# Regional Review Finding

**RE:** Development of Regional Impact (DRI) Review

**Name of Proposal:** Lotus Grove DRI 4360

**Description:** A DRI review of a proposal to construct a mixed-use development with 780 residential units, 160 hotel rooms, 13,364 SF of retail space, and 53,454 SF of restaurant space on a 13 – acre previously developed site on Buford Highway just east of I-285 in the city of Doraville in Dekalb County.

CONCEPTUAL  
SITE PLAN

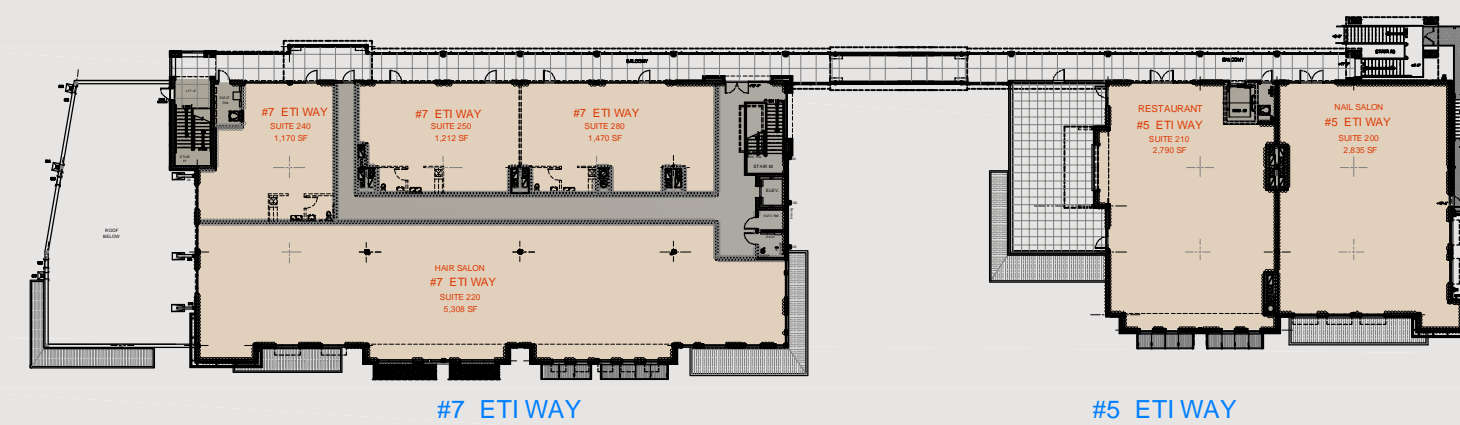
The FEMA coverage for the project area shows areas of 500-year floodplain (Zone X) along the unnamed blue-line stream, with one branch extending into the project property near the proposed detention pond. Other than the detention pond, none of the new development appears to be near the floodplain areas. Any work in the Zone X areas will need to meet all applicable requirements under the City's floodplain and future floodplain ordinances.

The project should adequately address the impacts of the proposed development on stormwater runoff and downstream water quality. The Stormwater Management section of the DRI Additional Information form states, "Detention pond as shown on the site plan is proposed." The final project design should adequately address the impacts of the proposed development on stormwater runoff and downstream water quality.

Yes. Streets within the development should accommodate bicyclists.
